Portugal Street East, The Fairfax

Design Justification Statement

The following presentation has been produced to set out the developed design compared to the approved planning drawings. The drawings are all labelled with reference to Schedule 1.0 which sets out the design revisions.

Block 2, South West Elevation - Proposed Design

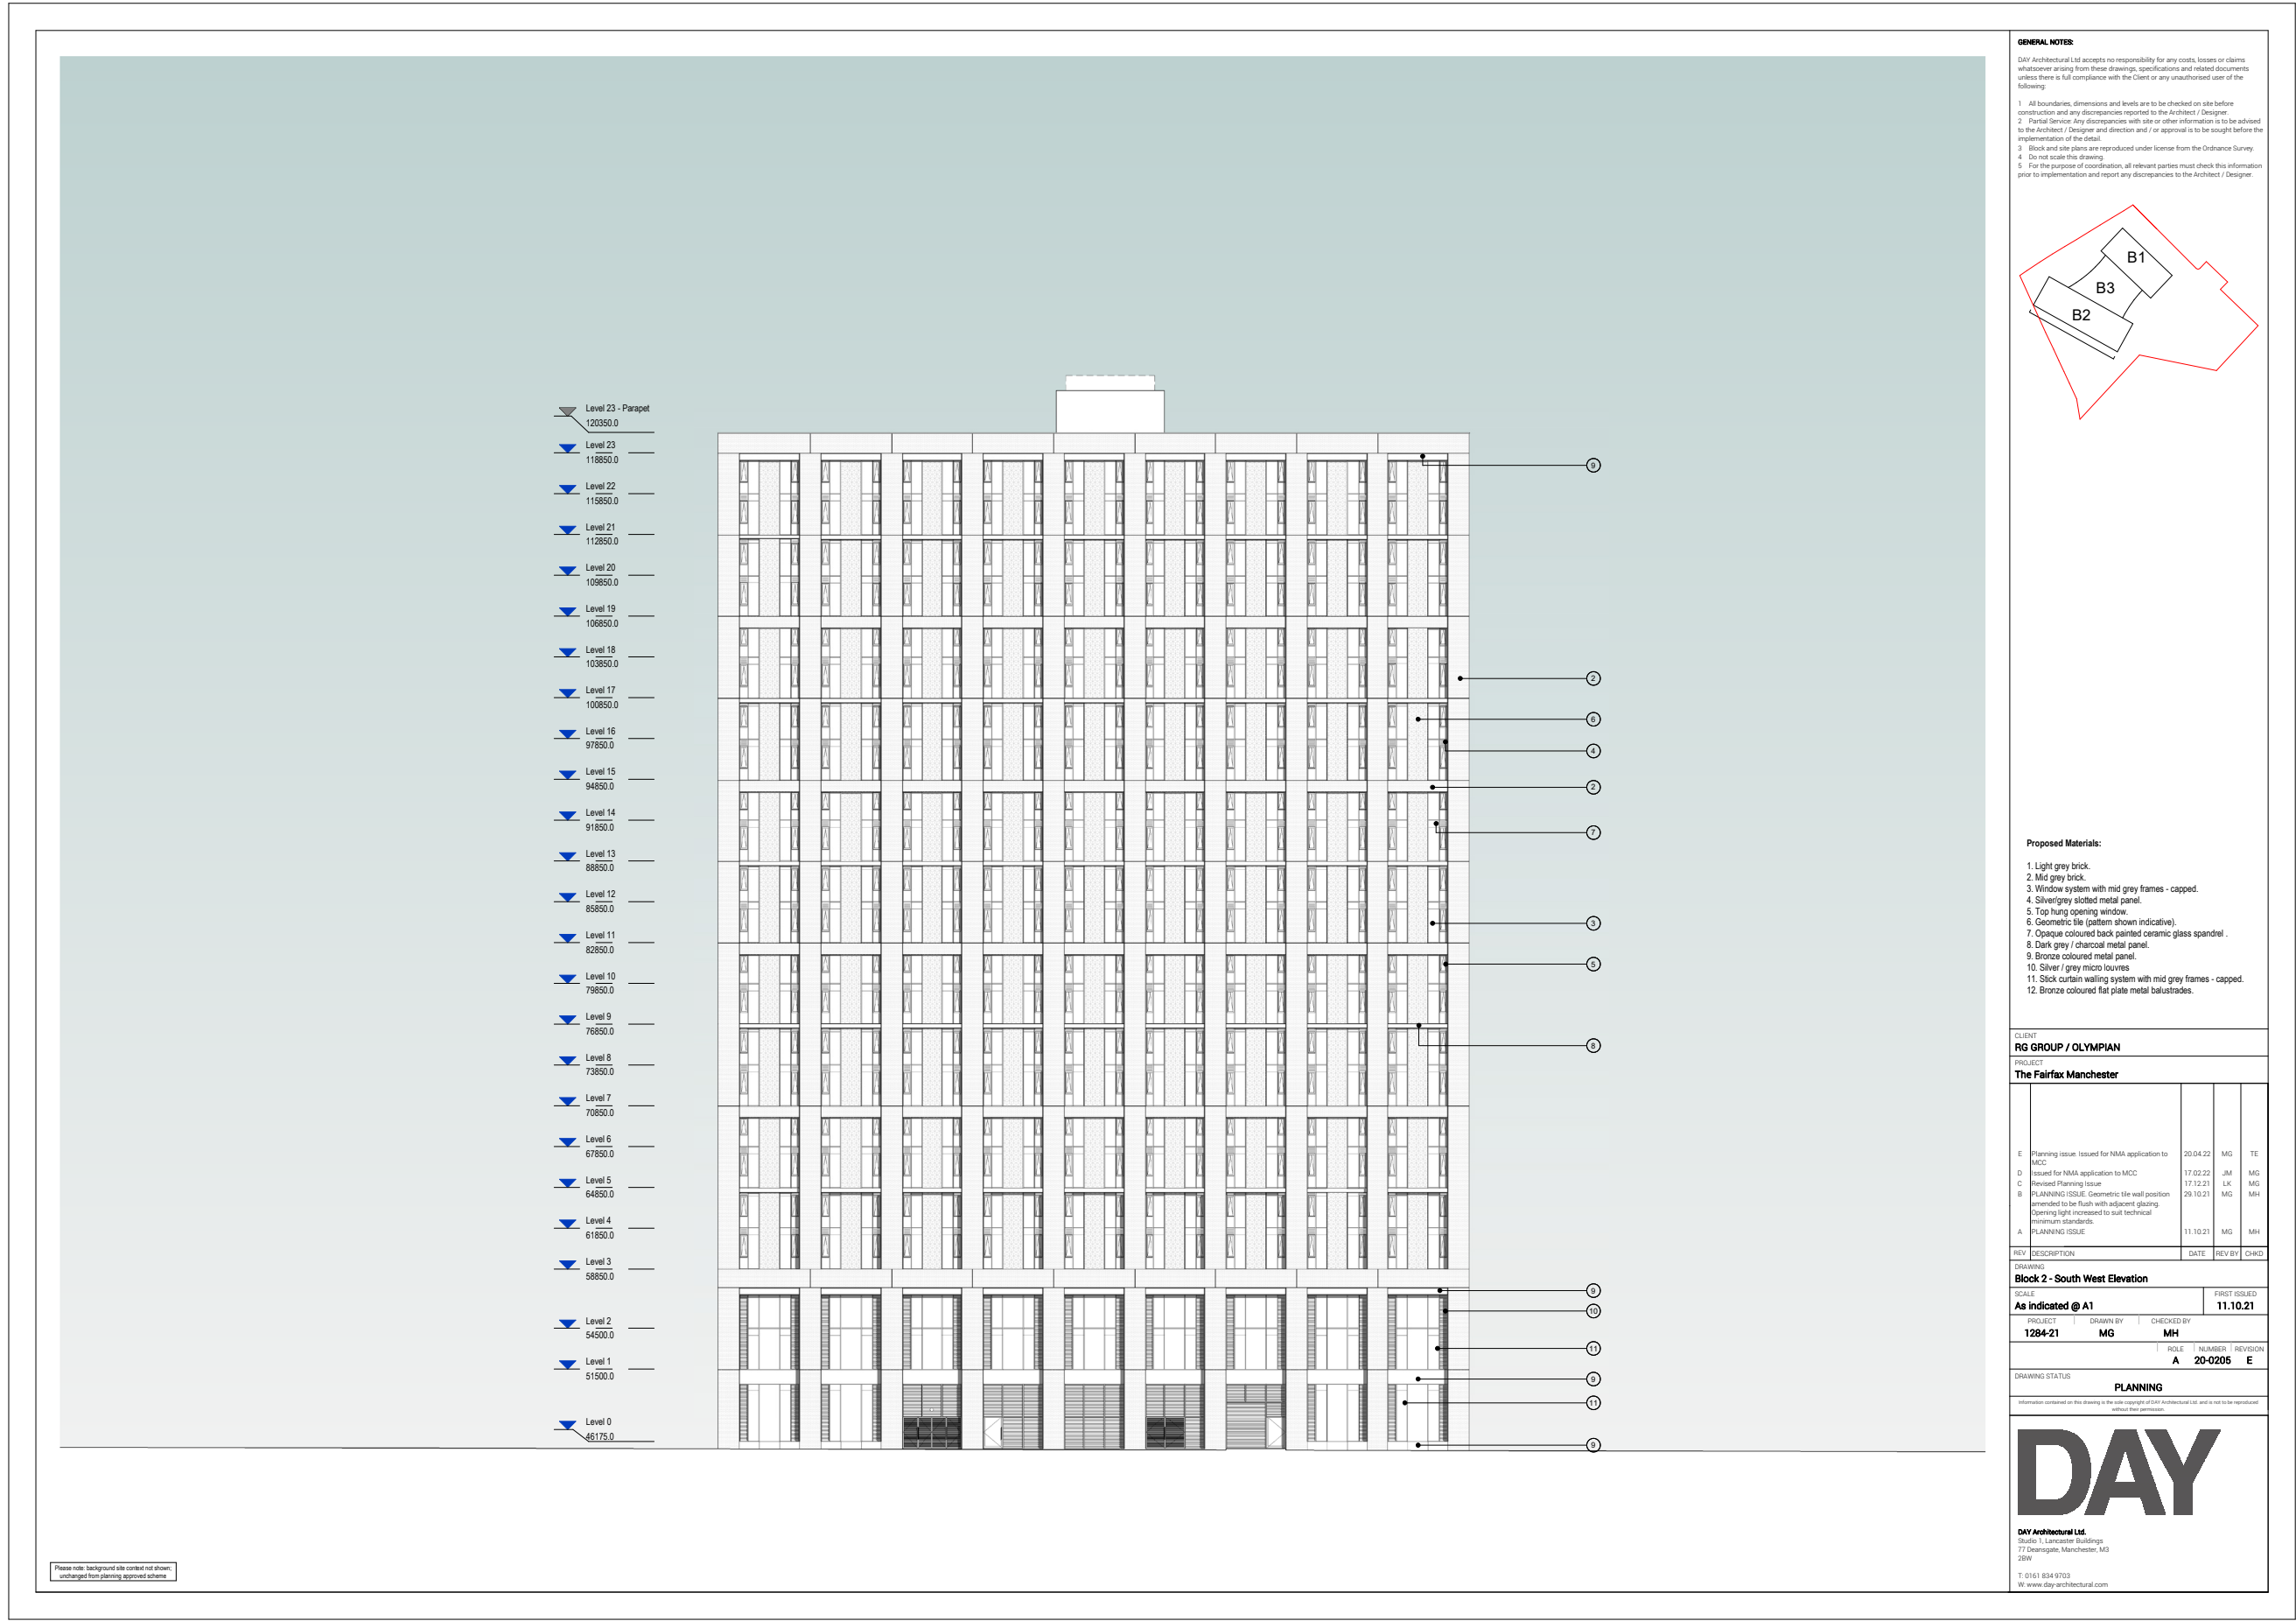
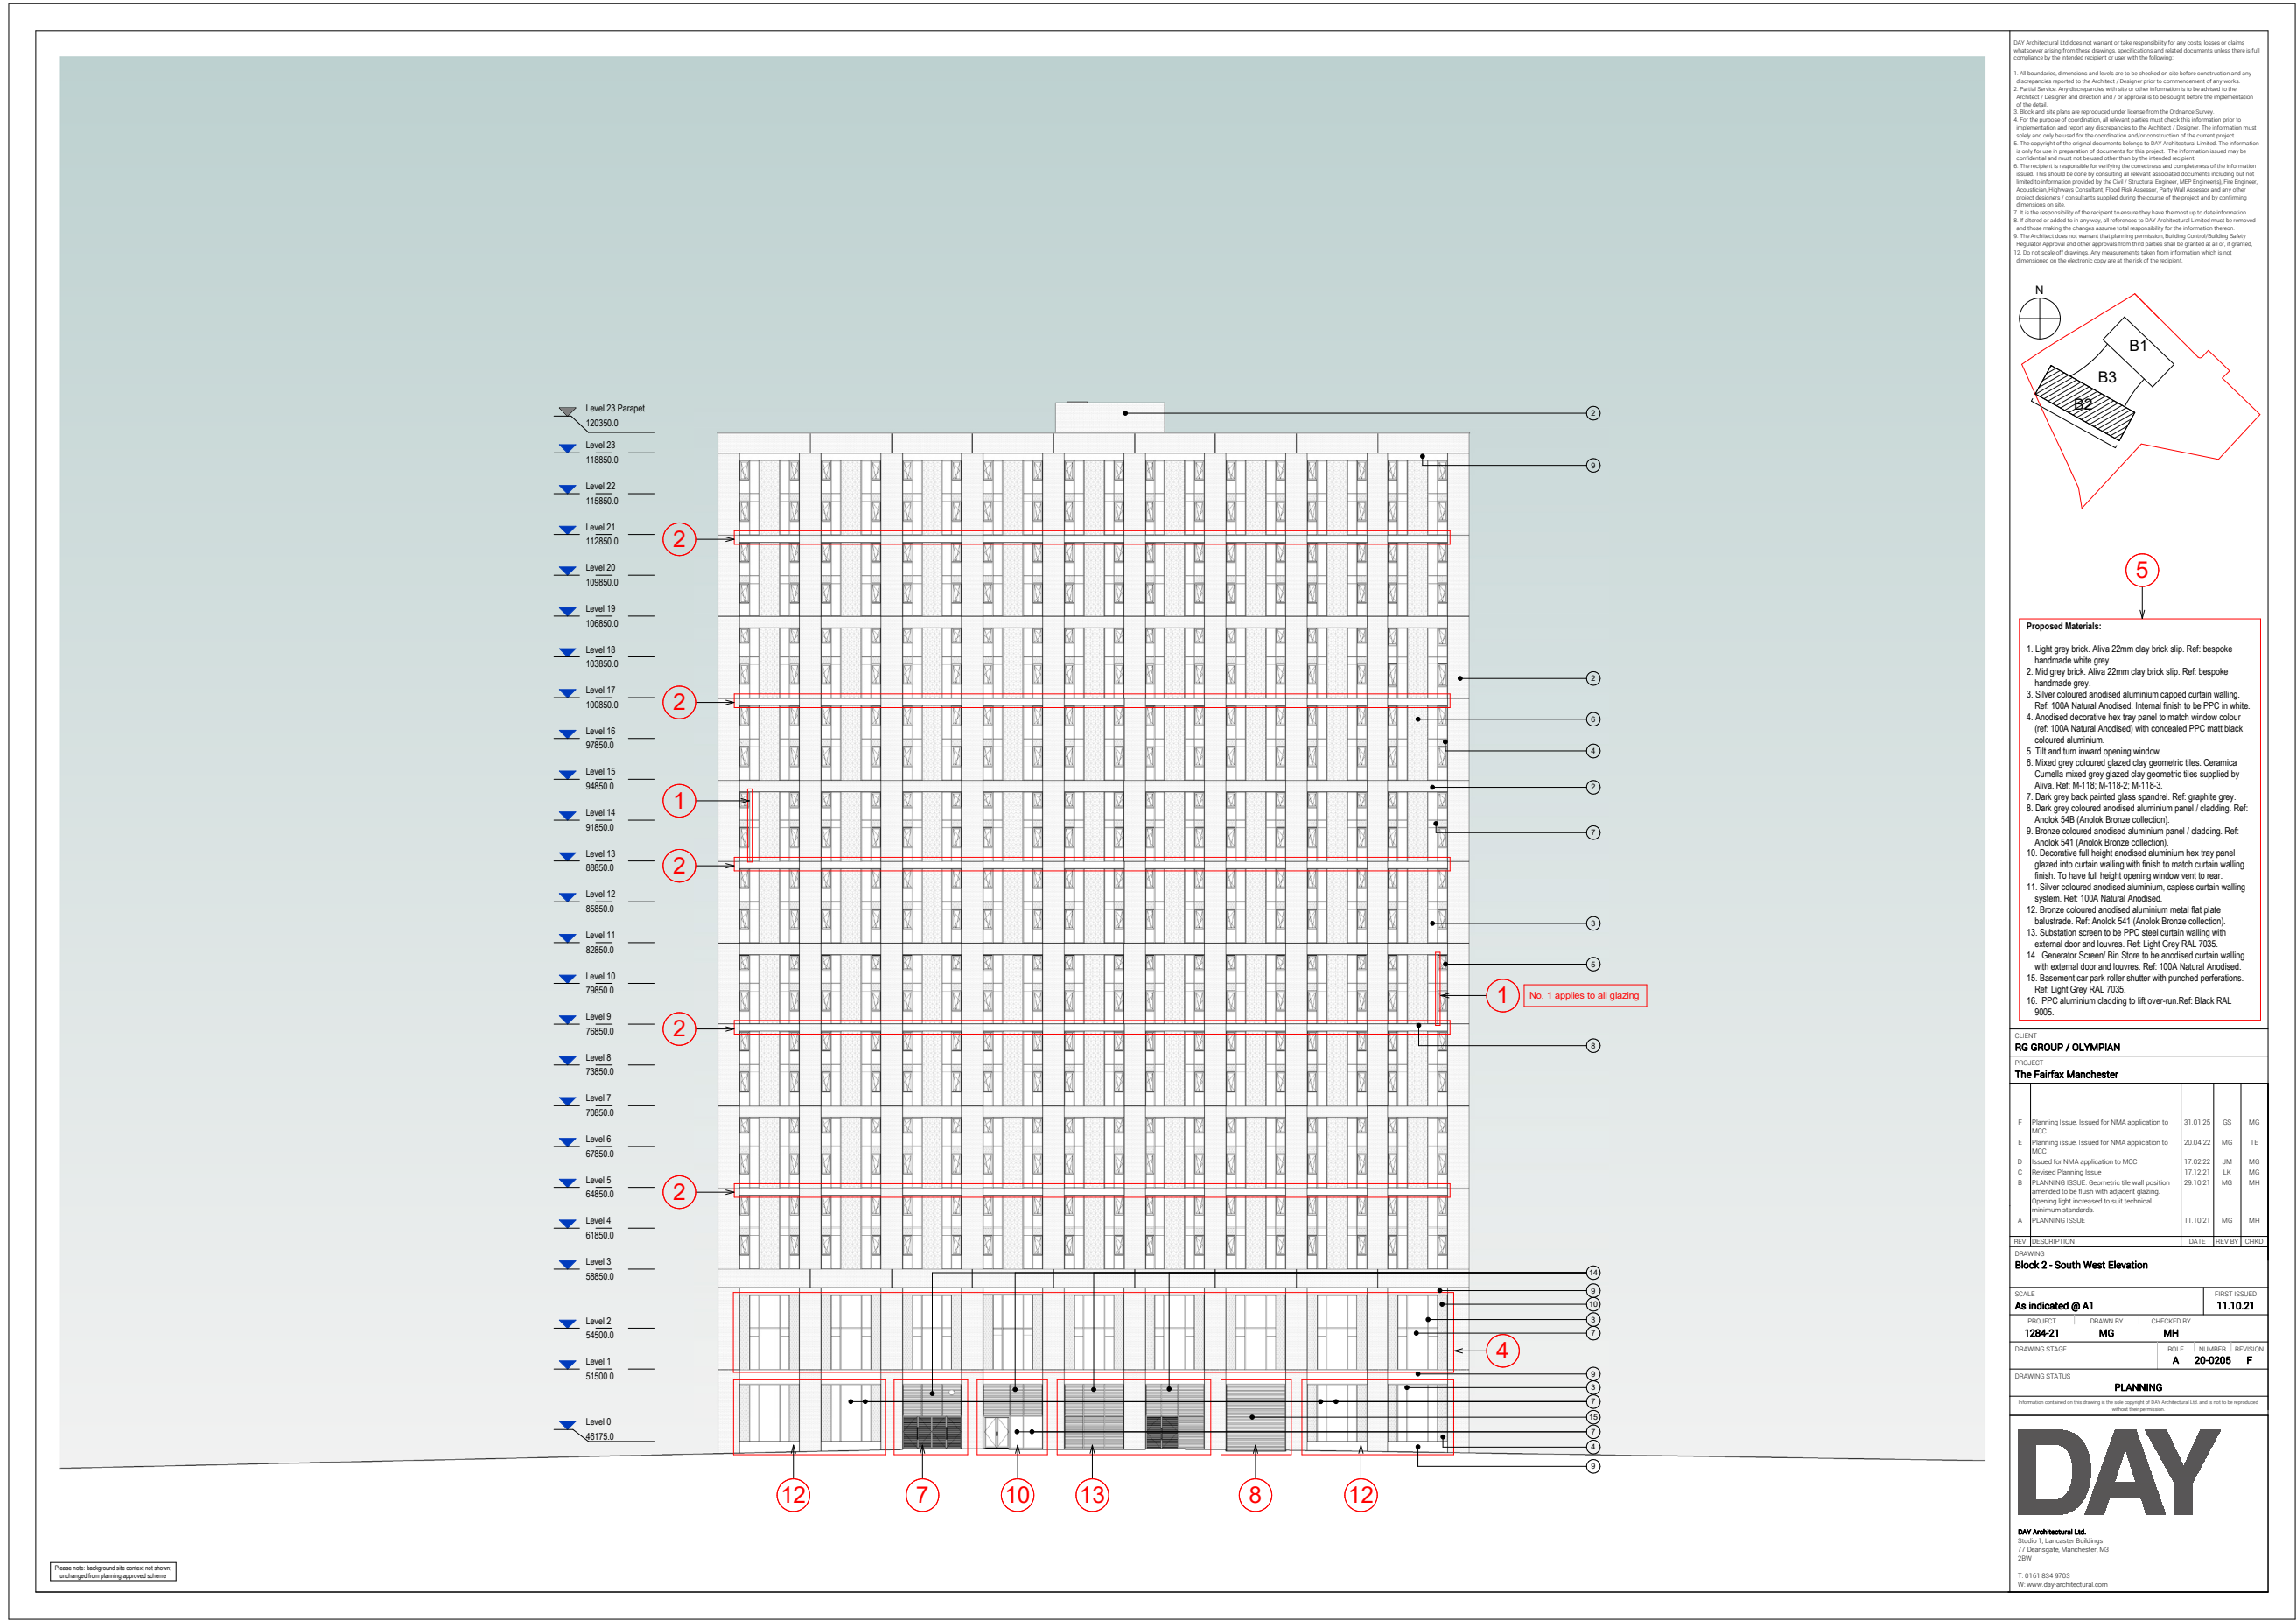
2	Block 2 external walls	Height of the feature charcoal metal banding to Block 2 increased in height from 300mm to 525mm from Level 3 upwards. Metal banding reveal has also decreased to 150mm in accordance with approved sample panel.	Due to the inherent design of the Block 2 elevations, the mechanical ventilation zone on the facades is halved every four stories due to the introduction of the 300mm deep charcoal band, which in turn halves the free area achieved by the ventilation and MVHR system. Due to the reduced area, it is not feasible to provide sufficient mechanical ventilation without finding additional ventilation area on the facades The charcoal band is recessed from the front face of the primary brickwork, and is in a darker grey than the brickwork The height of the charcoal band is increased to provide sufficient space to enable the mechanical ventilation route to be included within the metal banding, and allow for the intake / extract vents to be located to the underside of the banding	20-0201 REV F 20-0202 REV F 20-0205 REV E 20-0206 REV E 20-0304 REV E 20-0305 REV E 20-0307 REV E	20-0201 REV G 20-0202 REV G 20-0205 REV F 20-0206 REV F 20-0304 REV F 20-0305 REV F 20-0307 REV F
